LIGO-T070087-00

*ADVANCED LIGO*

Second Report to the HAM-SAS Evaluation Committee

This report is a follow up report to the initial report provided to the HAM-SAS evaluation committee, [T070079-00](#). In this report answers to questions posed by the committee are provided as well as an update on the latest results from LASTI prototype testing..

**Figure 1: Horizontal Isolation Performance of HAM SAS.** Note the vertical axis units are in  $m/\sqrt{Hz}$ . The Guralps are mounted on the ground and the GEO signals are the table geophones. [this is Figure 3-3 from T070079-00]

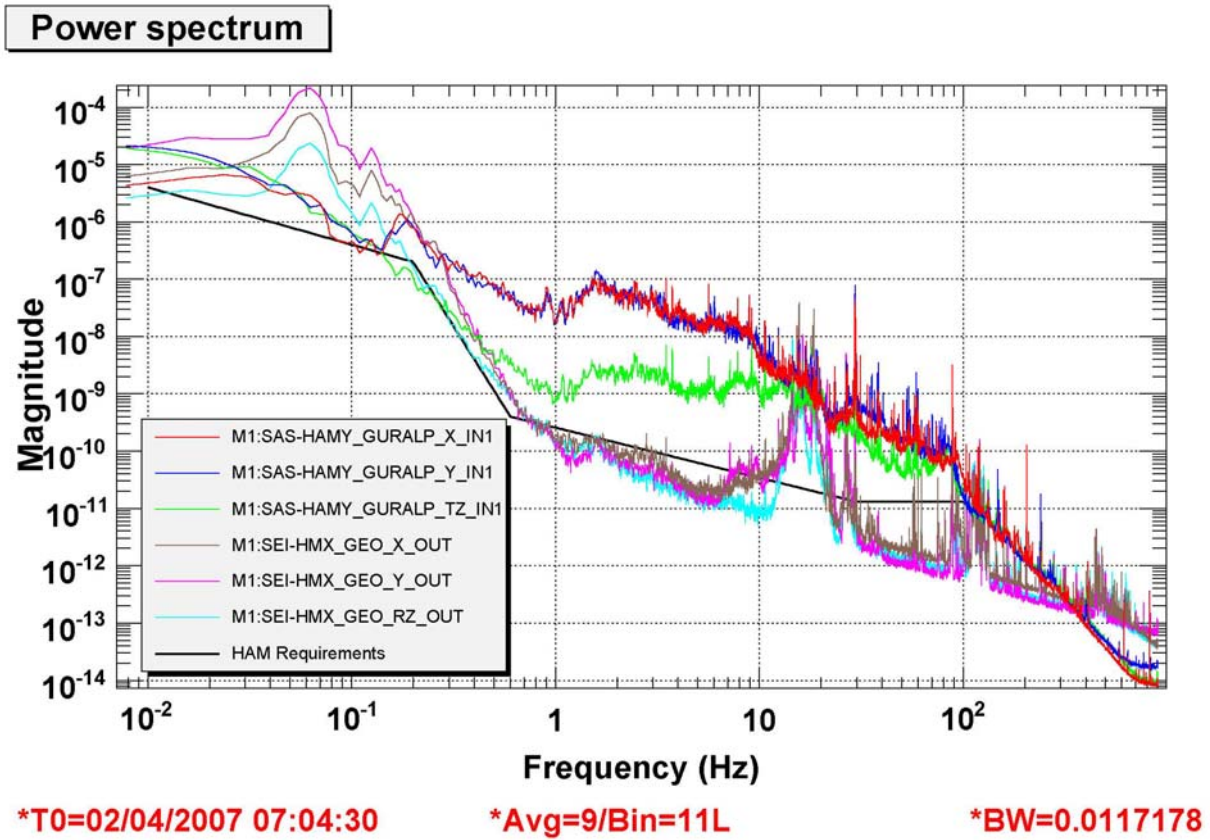
3) *Fig 3.3 and 3.4 and page 9. Why are the resonances in the vertical springs in 10 to 30 Hz region (as yet undamped) so clearly coming through in both horizontal and vertical directions?*

In the first report to the committee (T070079-00, section 3.4, pg 9) we attributed all of these undamped modes to the vertical stepper motor springs; this was not completely correct. These resonances are in part due to the vertical stepper motor springs, mounted on top of the horizontal attenuated stage (spring box). They oscillate like violin modes, pulling vertically on the vertical stage and recoiling horizontally against the spring box. In addition, the tilt-stabilization springs which act horizontally on the optics table, through a lever arm to impose a restoring moment, also contribute to these modes. Both can be eddy current damped (like the horizontal stepper motor springs) and both can be improved by a relatively small mechanical redesign to use spring flexures (rather than coil springs) and a stiff bar rather than wires for the tilt-stabilization system.

**Figure 2: Vertical Isolation Performance of HAM SAS.** Note the vertical axis units are in  $m/\sqrt{\text{Hz}}$  [this is Figure 3-4 from T070079-00]

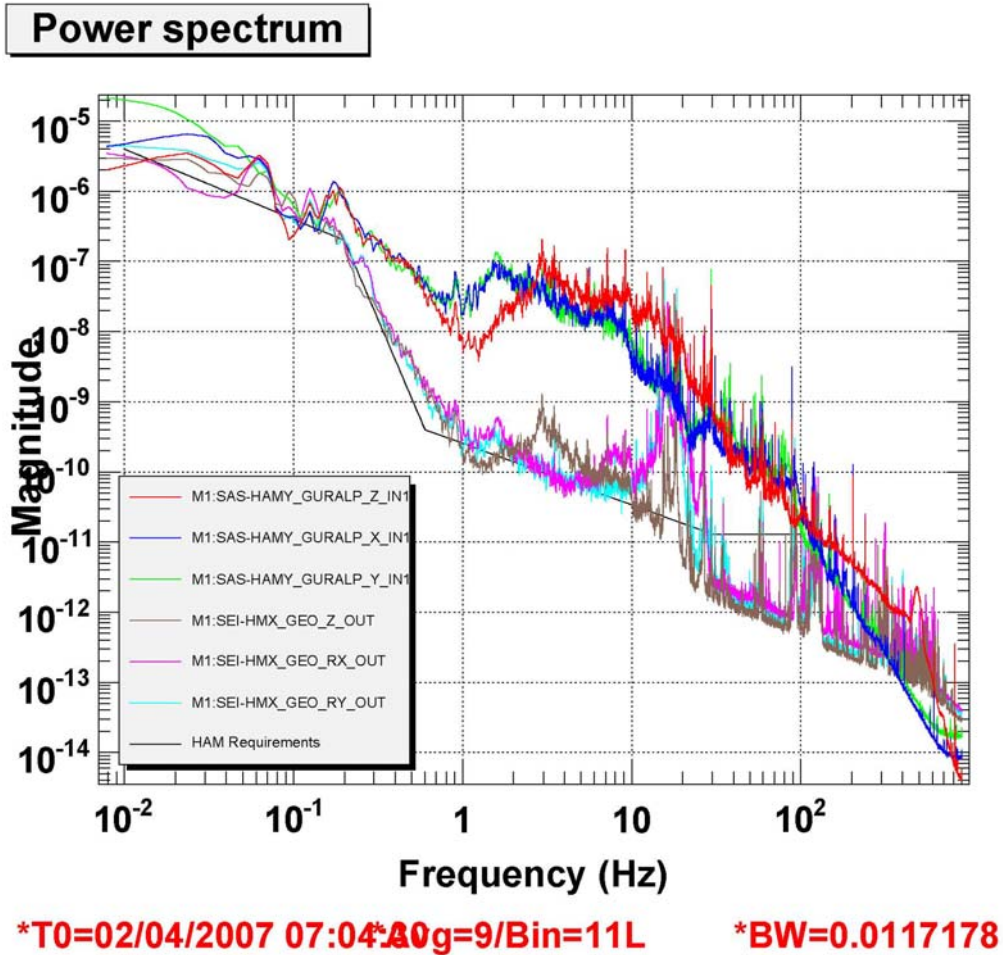
*In vertical (fig 3.4) there also appears to be a peak a round 3 Hz (brown curve) - is that another spring resonance?*

No, this is a well known feature in the ground PSD (perhaps a building resonance). It is visible on the ground seismometer channels in the vertical direction.

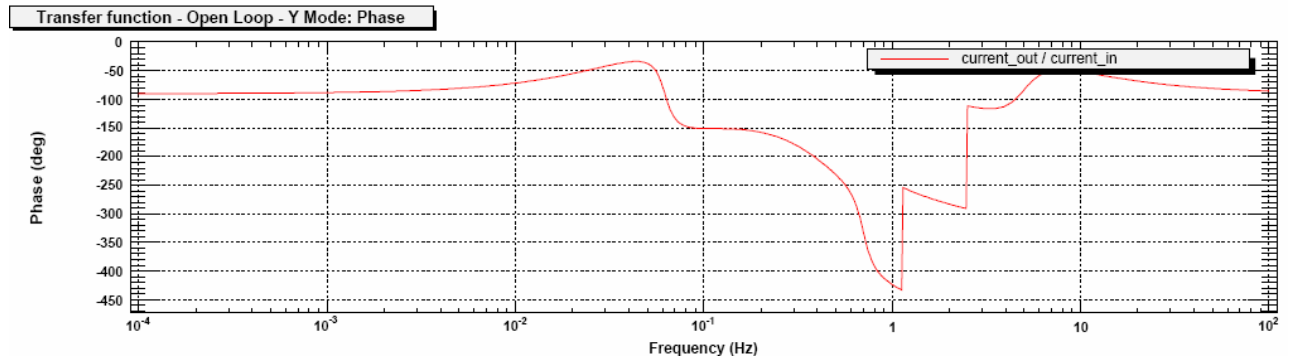
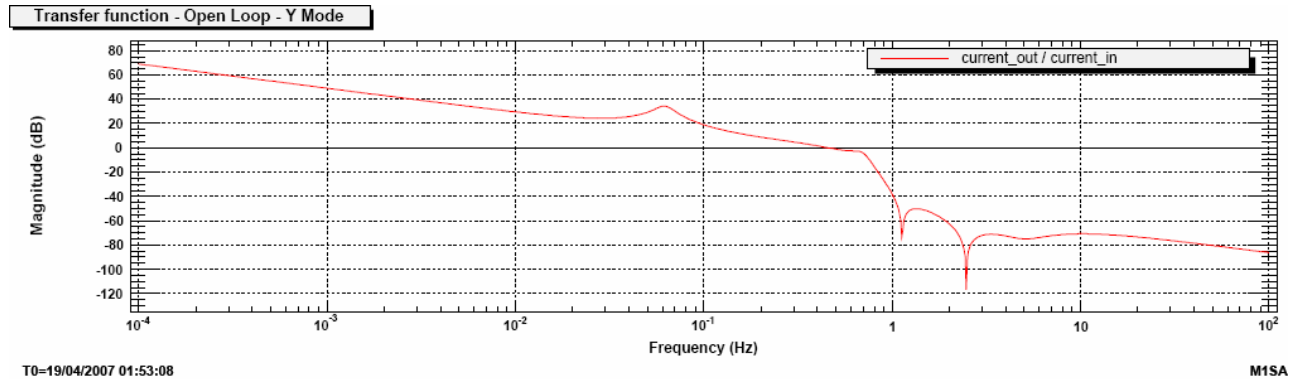
5) *It's not clear to me what the controls configuration was for the vibration data shown in 3.4. DC position control only, I guess, but on what modes and with what bandwidth?*

A modal based control was employed at the time the data was taken for figures 3-3 and 3-4 of T070079-00, and ever since. The canonical modes are projected with a frequency independent matrix that converts the 4 horizontal LVDT position signals into X, Y and RZ (horizontal translation along the beam line, horizontal translation transverse to the beam line, and rotation about the vertical) and the 4 vertical LVDT position signals into Z, RX and RY (vertical translation, rotation about X and rotation about Y). All of the 6 modes (X,Y,Z, RX, RY and RZ) were under control. All 6 modal degrees of freedom had a simple integrator (zero frequency pole) with a gain set to achieve a rather low upper unity gain frequency (about 0.1 Hz in all cases). In addition the vertical degrees of freedom had positive proportional feedback, with no roll off in frequency, as the Electro-Magnetics Anti-Spring (EMAS) control to lower the vertical stage resonances.

More recently, the upper unity gain frequency for the negative feedback control (DC integrator control) has been increased to  $\sim 0.5$  Hz horizontal and  $\sim 1.5$  Hz vertical, in order to more effectively decrease the motion at the rigid body resonances of the system. In order to avoid exciting the spring resonances at higher frequencies the compensation is rolled off, as indicated in Figures 11 and 12. However this strategy compromises the desired passive isolation at the microseismic frequency (0.15 Hz). More work on the control compensation is required to effect adequate suppression of motion of the rigid body modes while not defeating passive isolation at the microseismic frequency.

**Figure 8: Simulation of the Cross-Coupling of the Motion of one suspension to another**

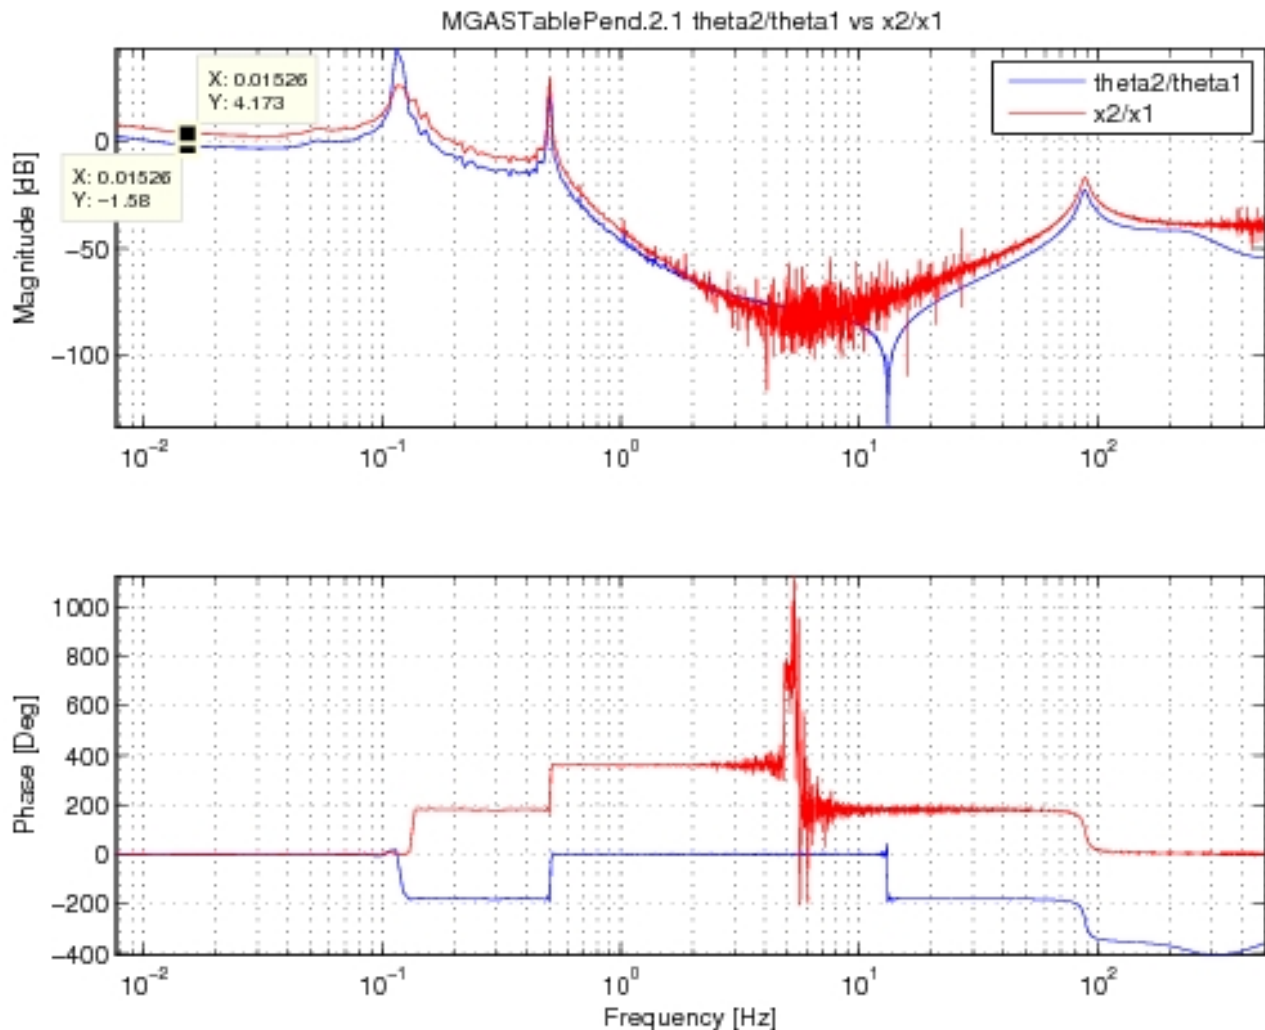
9) *Regarding interaction with a suspension: assuming the table really is moving around by microns or tens of microns, a triple suspension would need to move around with respect to the SAS table by this amount, to keep a cavity locked. Has any analysis been done to determine the interaction/stability of this scenario? It wasn't clear that any of the stuff in 3.9 addresses this.*

When thinking about interaction between HAM SAS and the triple pendulum it is often easy to dismiss this effect because of the mass differences between the HAM SAS optics platform and mass of the suspended optics. However this neglects a potentially more serious cross coupling path. This path is motions of the test masses causes torque changes on the table which in turn causes table tilts and other optics on the table follow the tilts. A simple worst case calculation ignoring the effect of the servo-control system goes as follows:

So in other words the cross coupling between a suspended recycling mirror on the HAM SAS table and the other suspended optics on that platform will be very significant. Note that this calculation does not take into account the effect a servo system.

Virginio and Valerio did a simulation using MBDYN and obtained the transfer function  $x_2/x_1$  (Figure X) where

This is a rather preliminary result and has not been reviewed carefully as yet. The simulation is a full multi-body, nonlinear simulation of the HAM-SAS system with the two pendulums added to the optics table. No controls have been added. The prominent peak at 0.5 Hz is the responding (1 m long) pendulum suspension. The peak at  $\sim 0.1$  Hz is the pitch mode of the HAM-SAS optics table. The suspensions are assumed to have infinite Q (the peak amplitude is not resolved). The amplitude of the transfer function at low frequency is 4 dB or a factor of 1.6. The above simple analysis indicates a factor of 0.3 for a 12 kg mass and a table tilt frequency of 0.1 Hz.
